SERVICE BULLETIN No 30-6

PRODUCTION CHANGE

SUBJECT: SYNCHRONIZING BLOCKS
VEHICLES: 3.2 MONDIAL, TURBO, 328, TR, 412

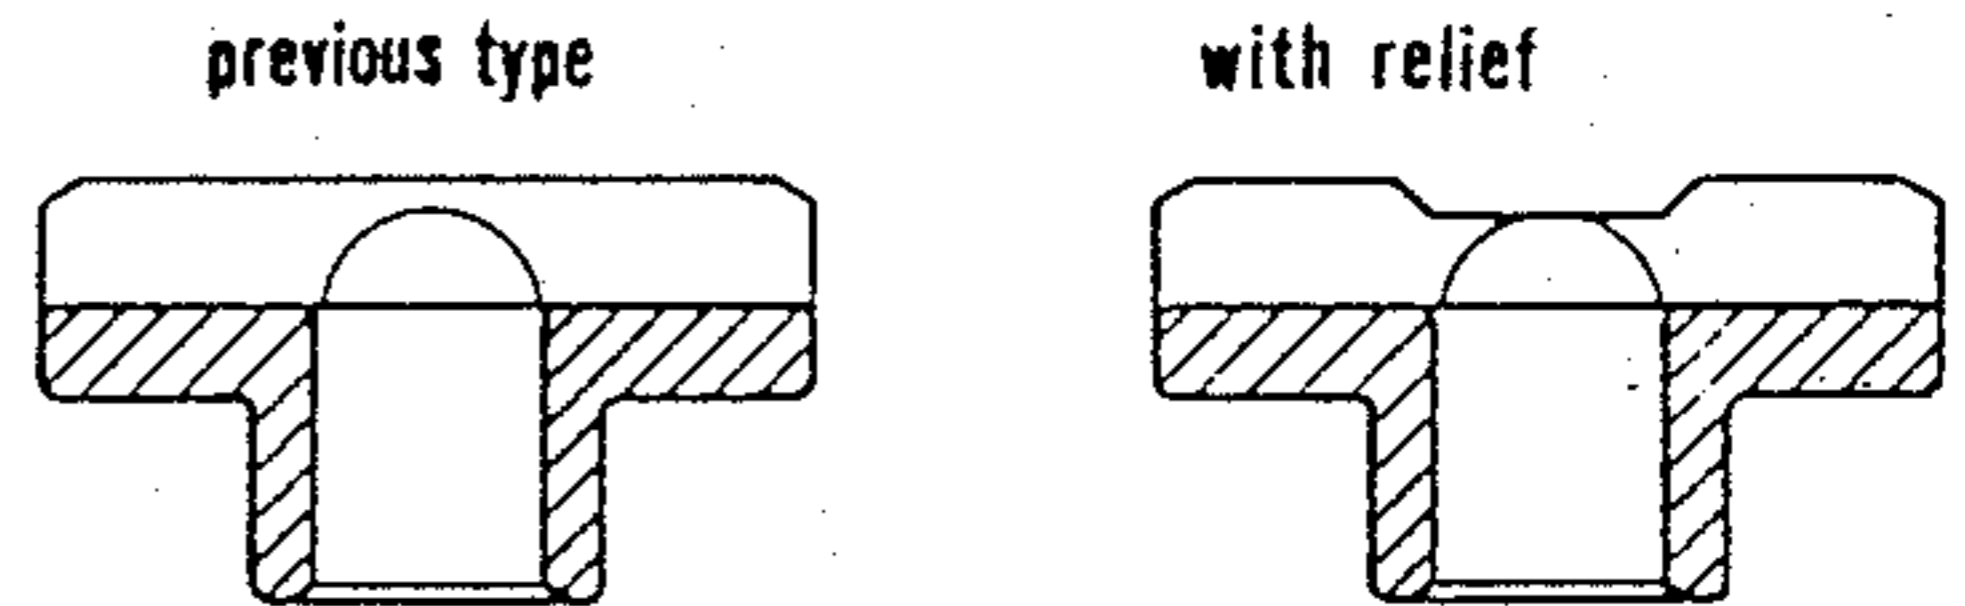
New synchronizing blocks are being used; they have a visible relief on the top surface, as shown by the layout. The new blocks keep the same P.N. of the previous ones with which they are interchangeable (P.N. 106042).

Higher resistance.

Reference spare parts catalogue: Use only the new type synchronizing blocks, previous type blocks, which you might have in stock, shall be returned under warranty.
